SITE ADDRESS: 18 & 20 The Serpentine, Bilgola Beach.

PROJECT- Revision 3 - Addendum to Arboricultural Impact Assessment (AIA) in relation to Development Application No. DA2023/0374 - Construction of a studio and car parking structure.

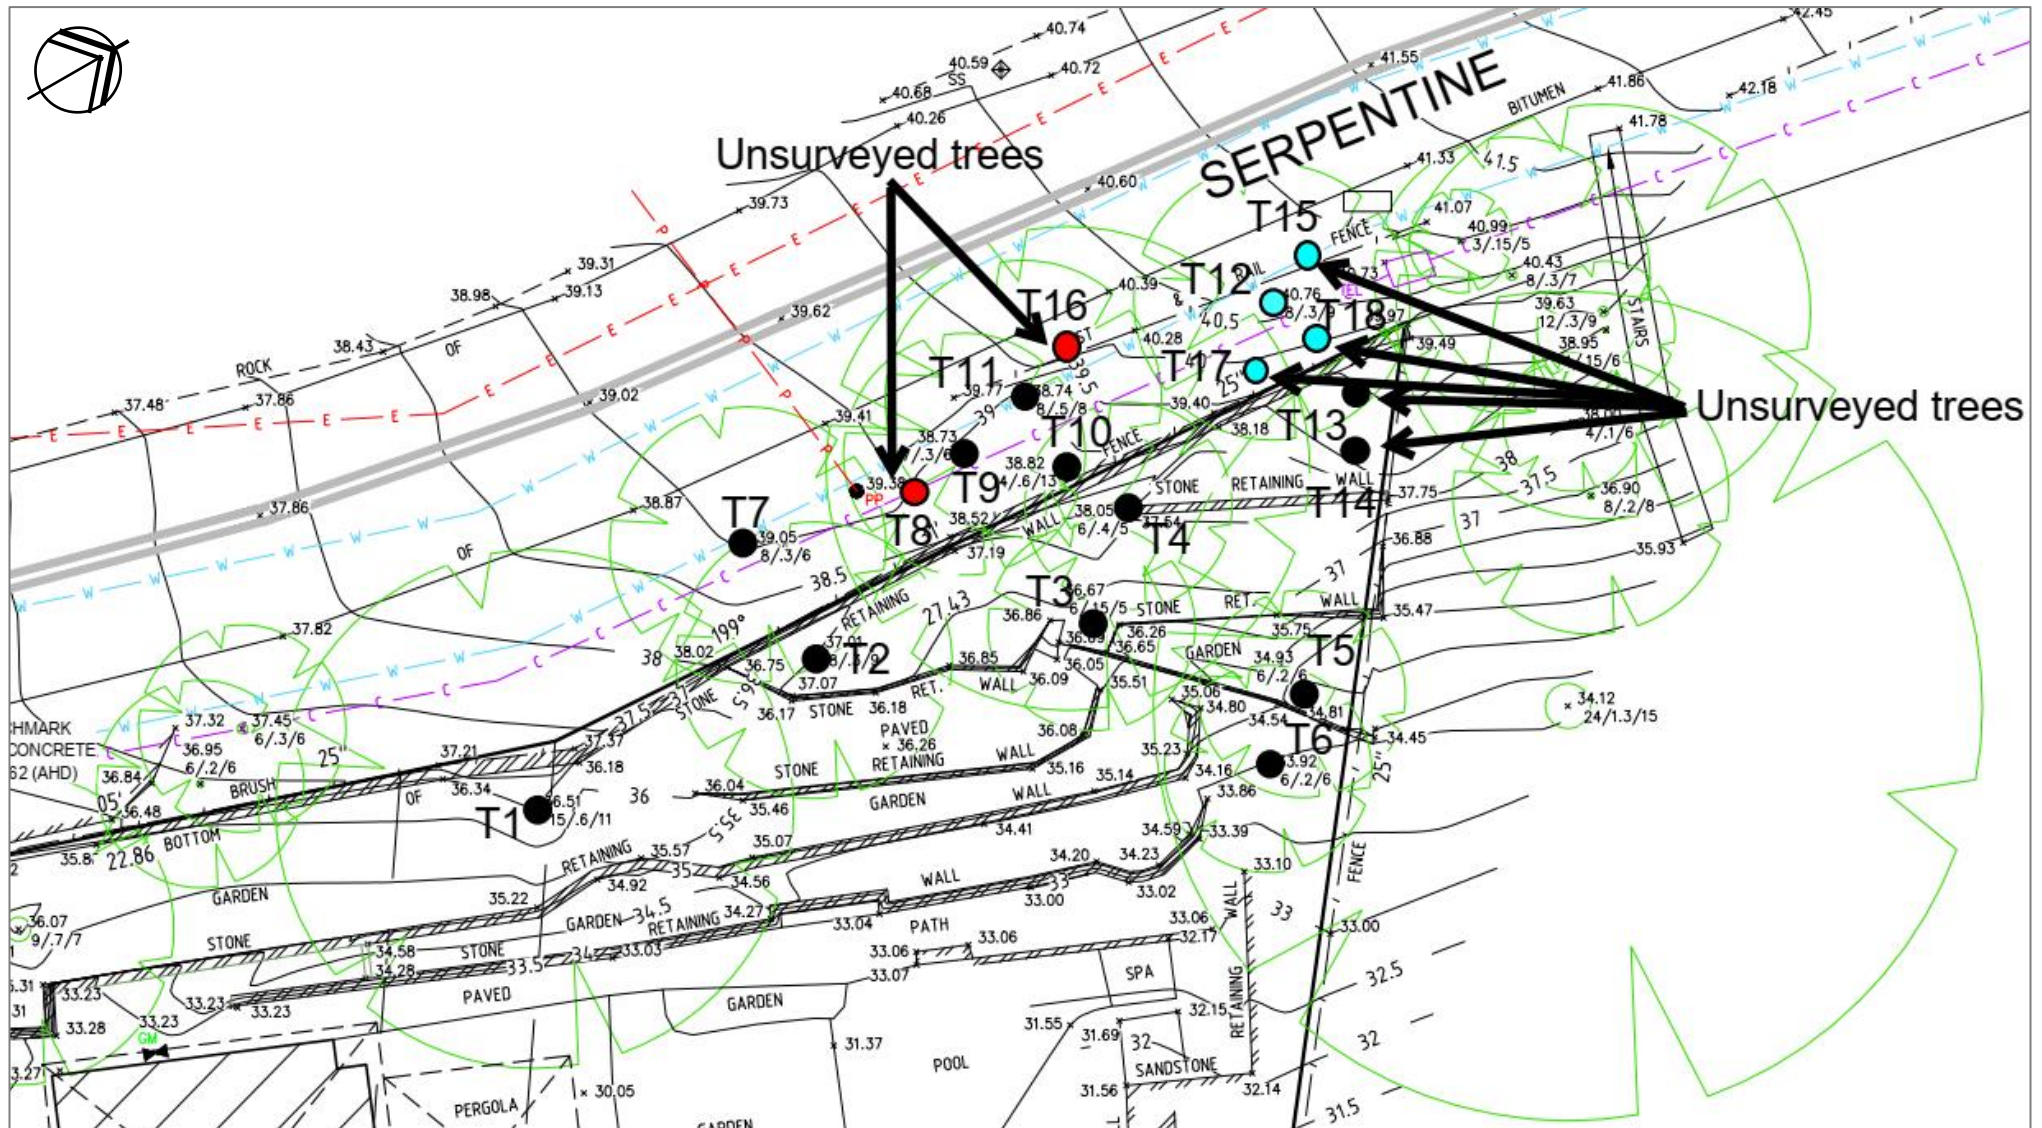
Several suckering¹ *Casuarina glauca* (Swamp she-oak) are located within the road reserve. Not all these suckers were discussed within the original AIA as they were outside the zone of impact for the proposal, and they had not been plotted within the Survey Plan. Tree 8 was marked up manually within the Survey Plan by Treeism for the original AIA. An additional four (4) suckers impacting the view line have been identified in the recent inspection (Tree 15, 16, 17 and 18, see Appendix B).

Tree 8 has the bulk of its canopy within the viewline, the pruning could not be carried out in compliance with AS4373, the required pruning would render the tree not viable for retention. Removal of Tree 8 is now recommended.

Tree 16 is located very close to the roadway edge and has a at base diameter of approximately 60mm, the canopy obscures vision and as such removal is recommended.

Minor crown-raise pruning of Tree 12, 15, 17 and 18 is recommended to allow clear vision. A maximum branch diameter of 30mm at the branch junction and 10% of total live canopy is all that is required to facilitate clear vision.

Cut to ground level Tree 8, Tree 10, Tree 11 and Tree 16. Given the suckering nature of the discussed trees DO NOT poison the stumps (as this can affect the parent trees).

Tree 9 is to be retained and protected, no pruning is deemed necessary.

Pruning of Tree 12, Tree 15, Tree 17 and Tree 18 is to be in accordance with AS4373-2007 Pruning of amenity trees, a maximum 10% of total live and canopy and branch diameter of 30mm is to be removed.
